APPLICATION NO.	FILING DATE	FIRST NAMED INVENTOR	ATTORNEY DOCKET NO.	CONFIRMATION NO.
10/605,663	10/16/2003	Ronald S. Lane		2662

Office Action Summary	Application No. 10/605,663	Applicant(s) LANE, RONALD S.	
	Examiner Gwendolyn Baxter	Art Unit 3632

This is the third office action for application serial no. 10/605,663, Bookstand that Folds Thin Enough to serve as a Bookmark filed October 16, 2003.

ATTACHMENT

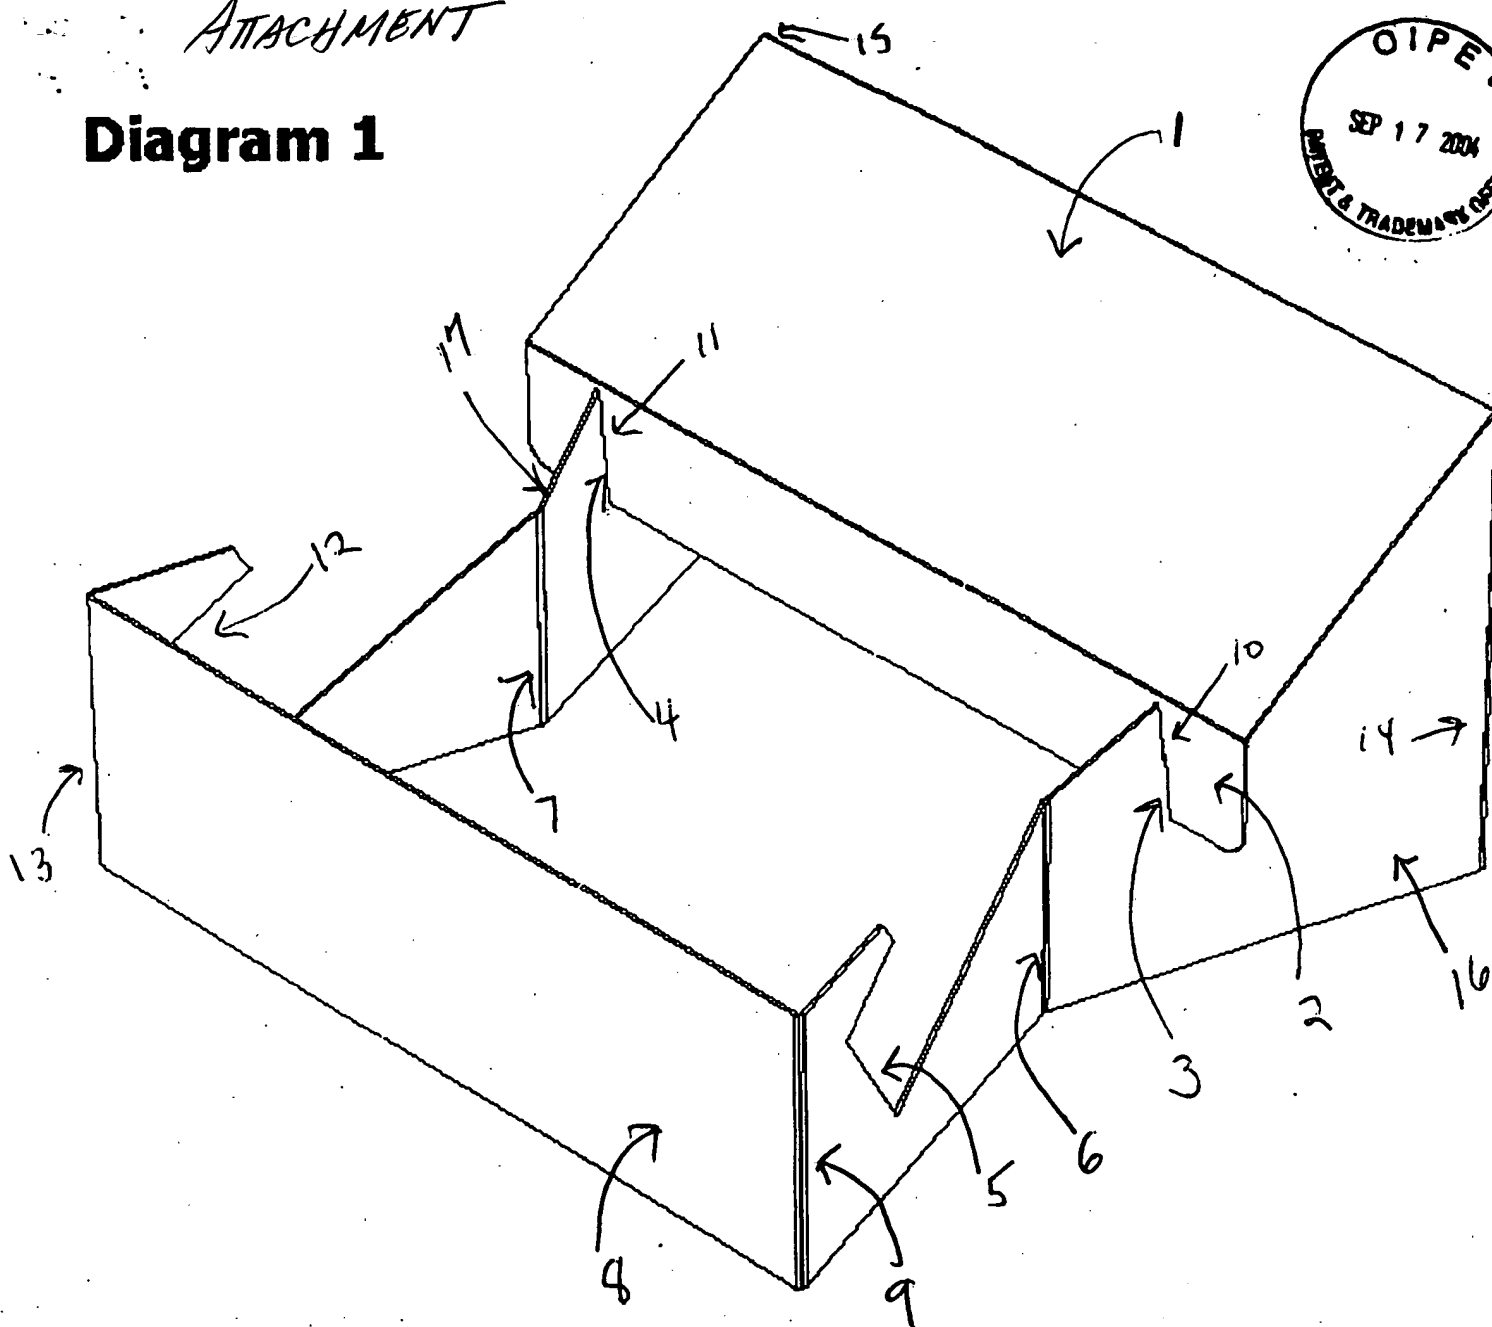
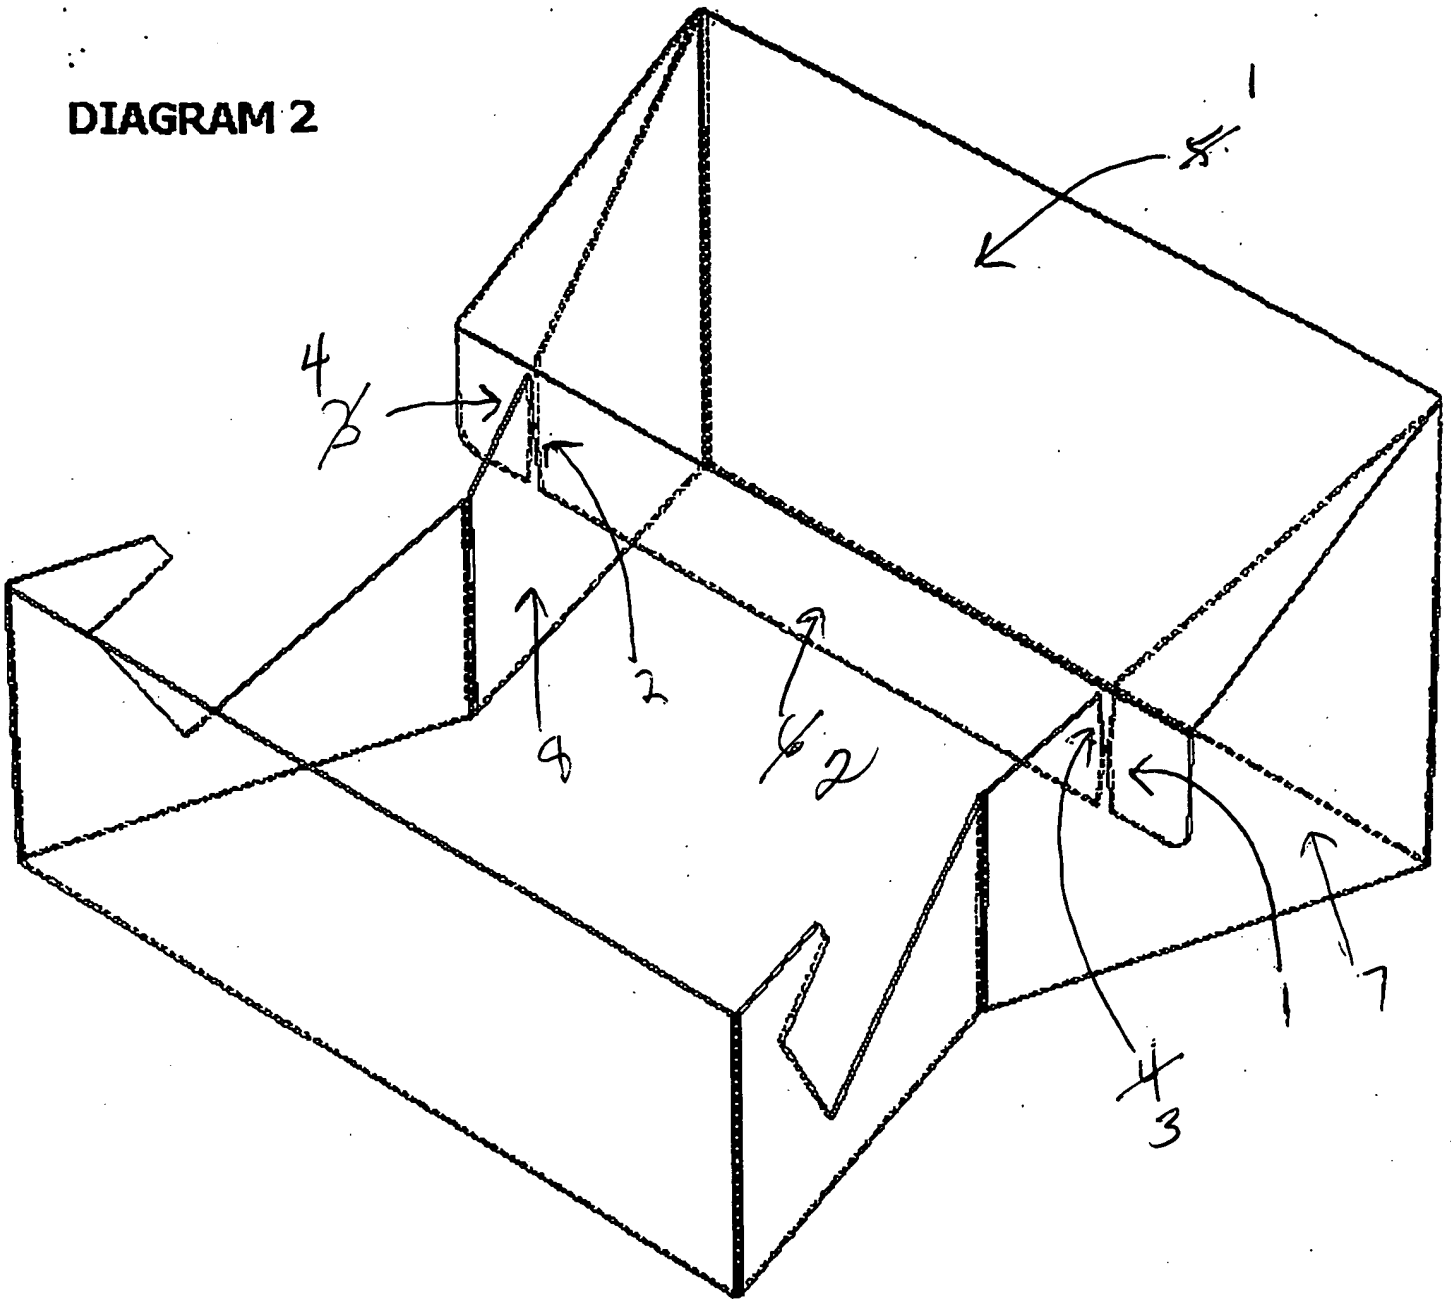
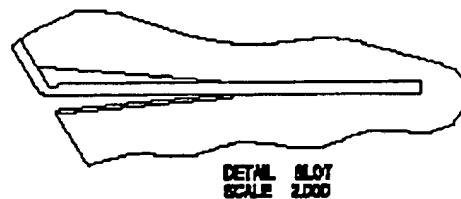
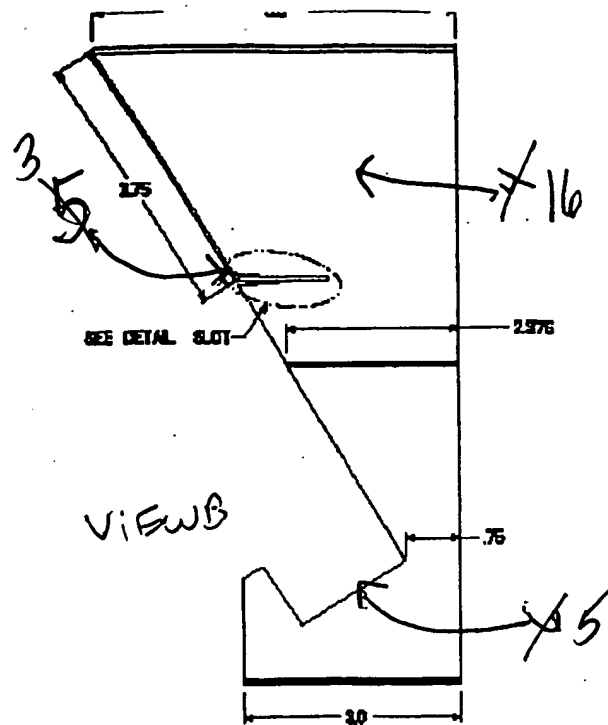
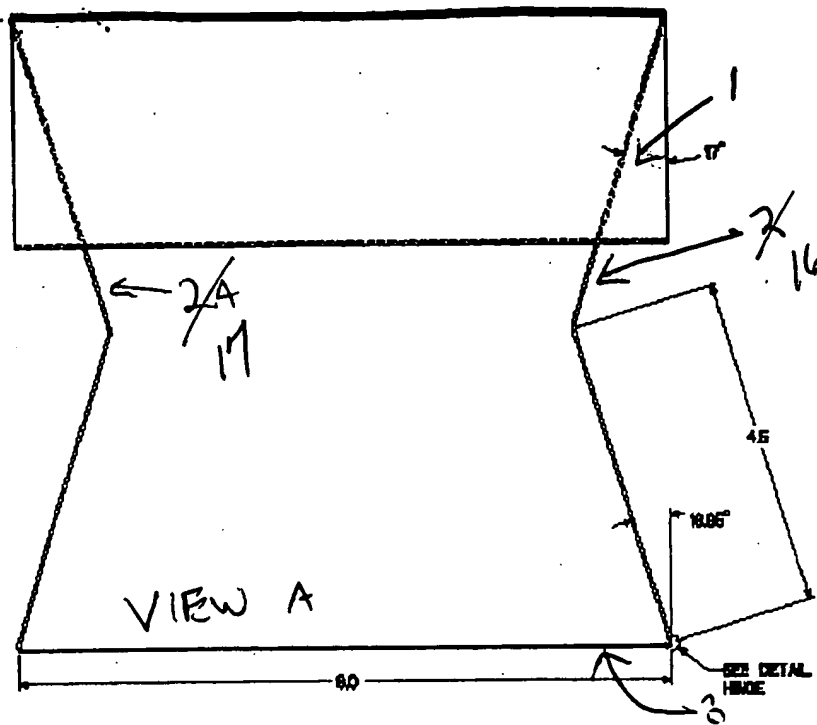
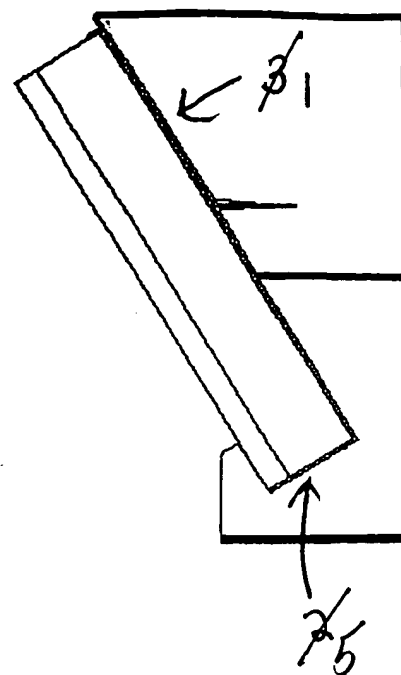
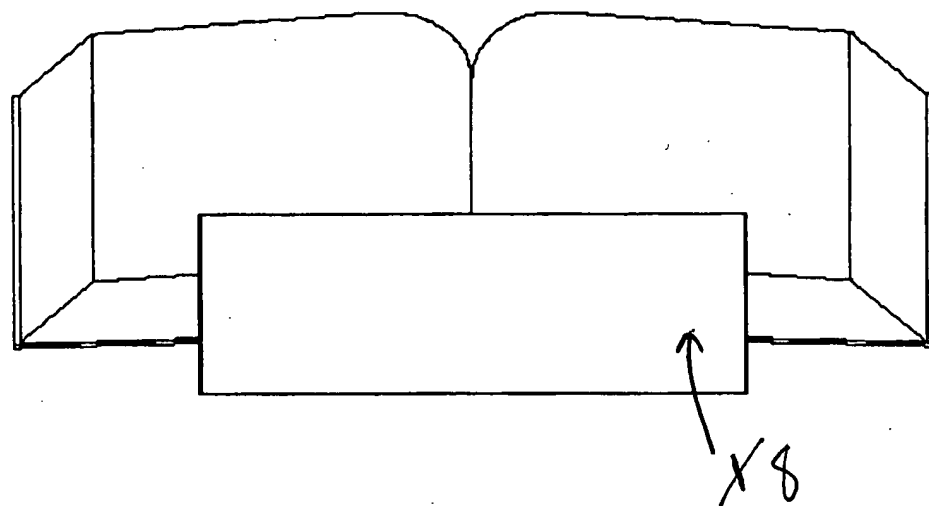
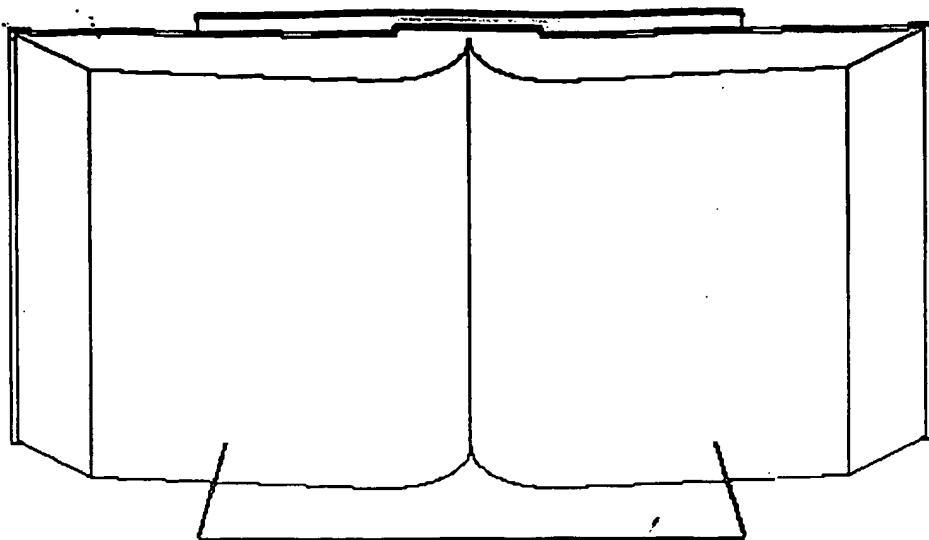
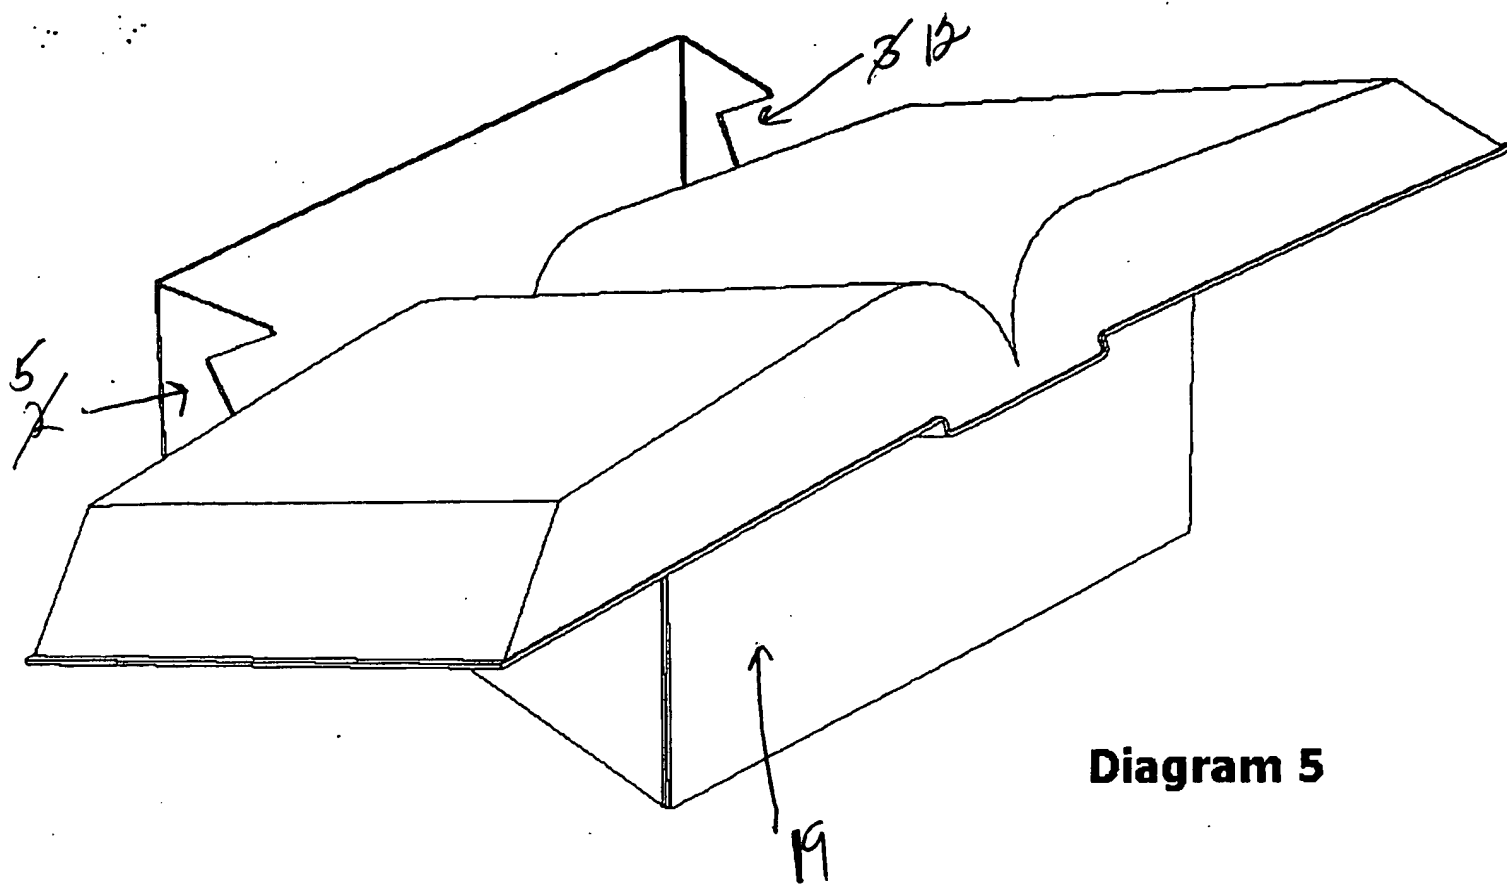
In order to reconcile the reference numerals in the specification and drawings, the following suggestions are made to correct different parts with the same reference numerals and/or different numbers for the same part. See modified copy of the drawing supplied by the examiner.

Corrected drawing sheets in compliance with 37 CFR 1.121(d) are required in reply to the Office action to avoid abandonment of the application. Any amended replacement drawing sheet should include all of the figures appearing on the immediate prior version of the sheet, even if only one figure is being amended. Each drawing sheet submitted after the filing date of an application must be labeled in the top margin as either "Replacement Sheet" or "New Sheet" pursuant to 37 CFR 1.121(d). If the changes are not accepted by the examiner, the applicant will be notified and informed of any required corrective action in the next Office action. The objection to the drawings will not be held in abeyance.
